ADDENDUM NO. 2

May 6, 2026

LIDDELL
LABORATORY
MOUSE PADDOCK
REPLACEMENTS

ENLARGED
SALLYPORT PLAN

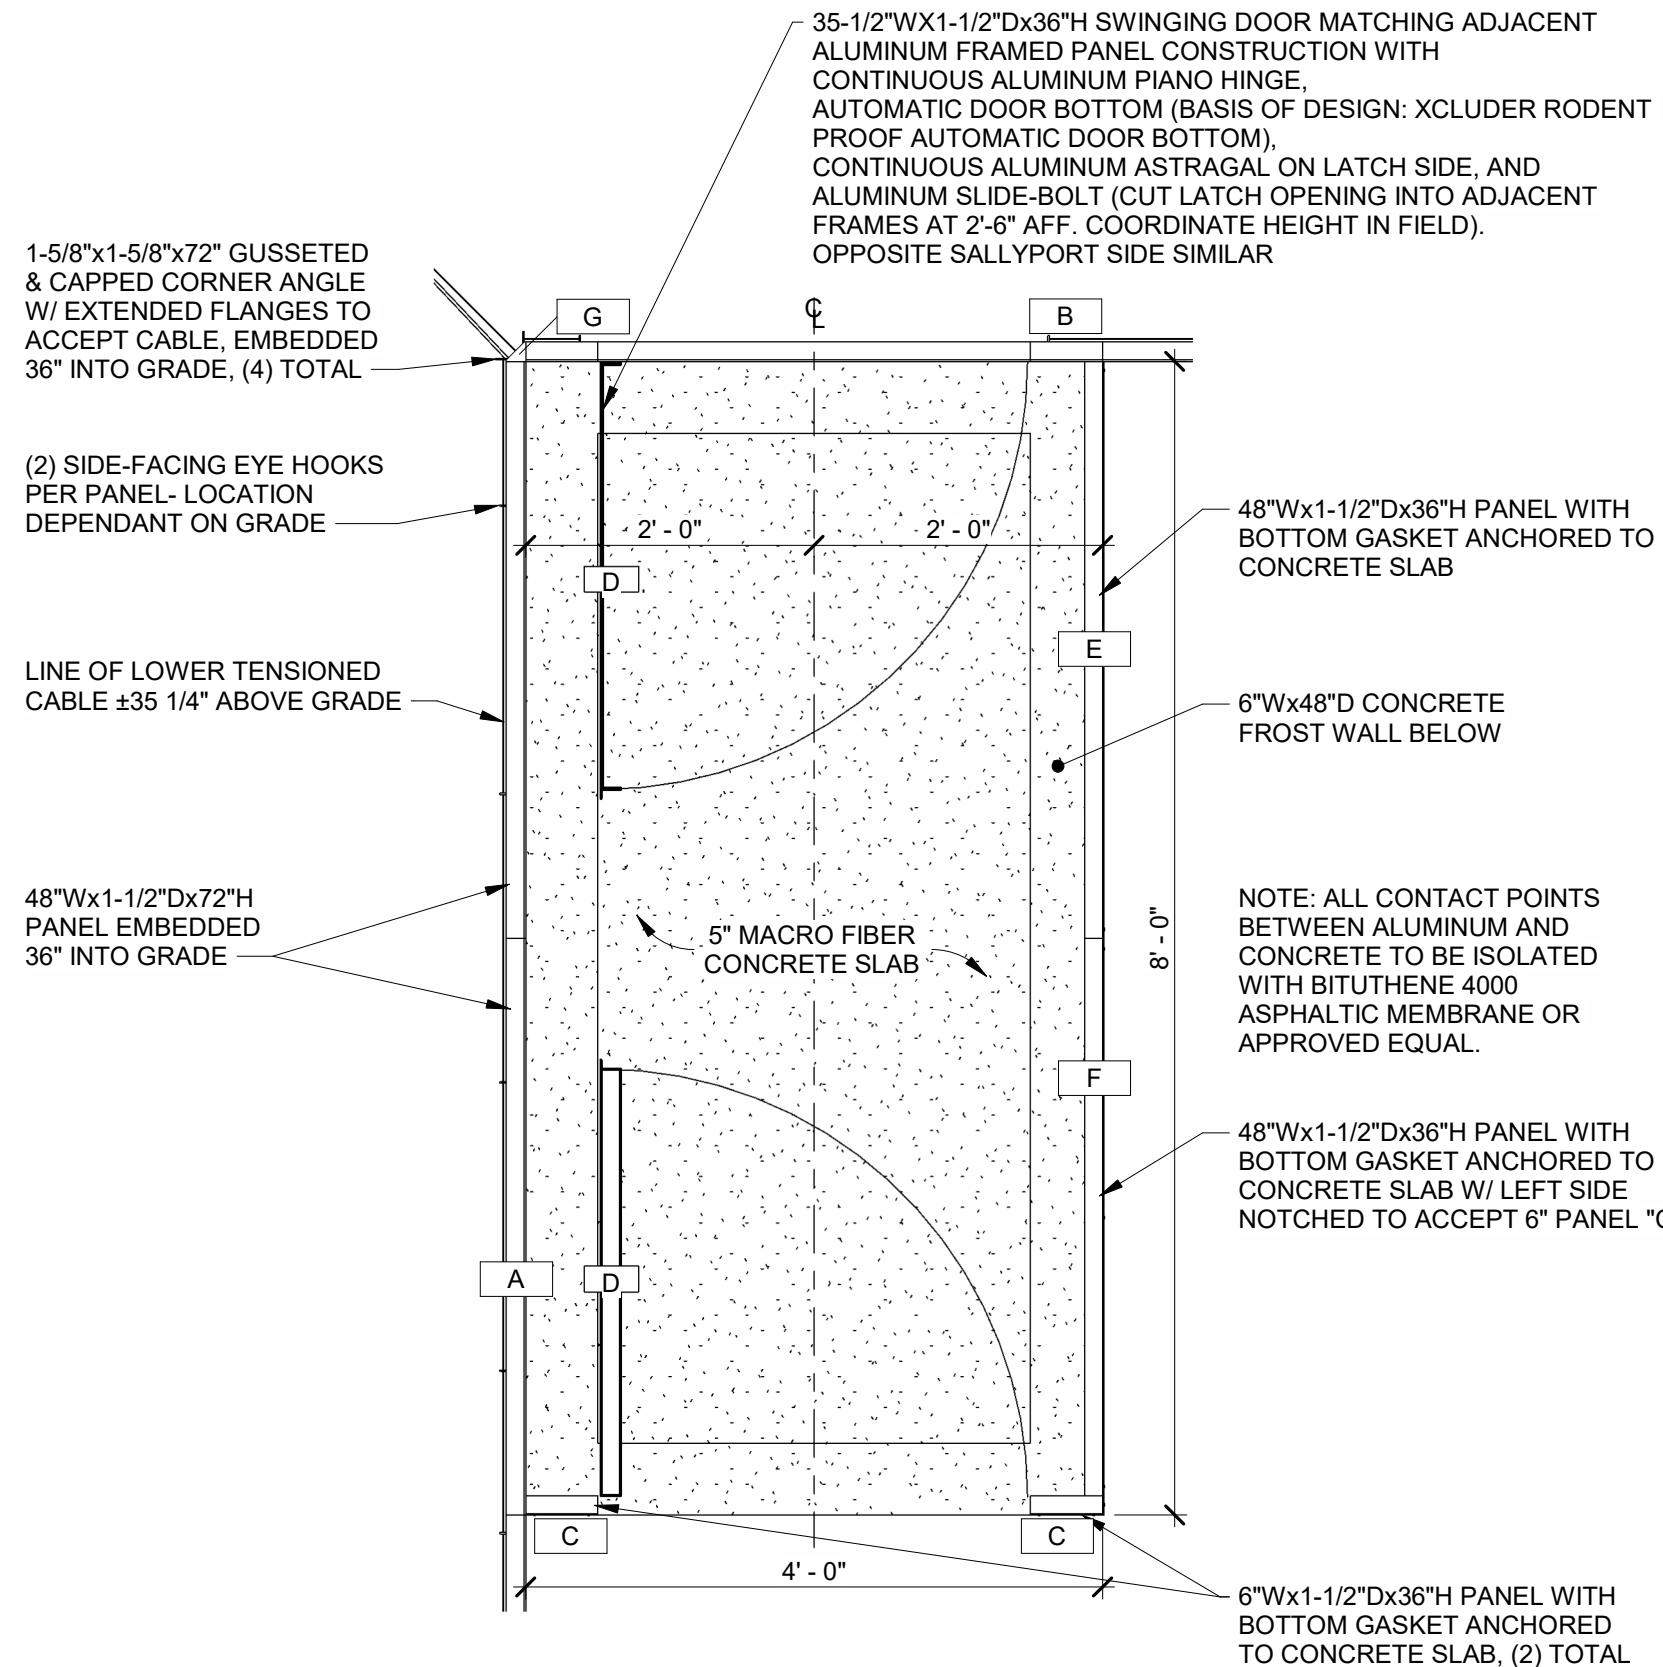
Item 6. Drawing C-102

DELETE 3/C102

REPLACE with diagram AD2-C1 – Enlarged Sallyport Plan, attached.

6 SALLYPORT DOOR 3D VIEW
NOT TO SCALE

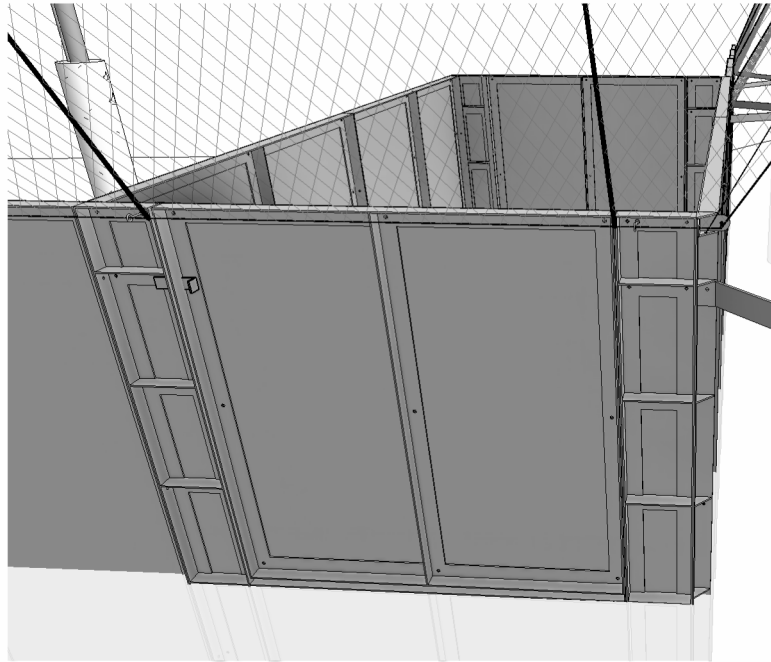
Item 7. Drawing C-102

ADD AD2-C2 – Sallyport Door 3D View, attached.

NOTE: ADD THIS DRAWING AS 6/C-102
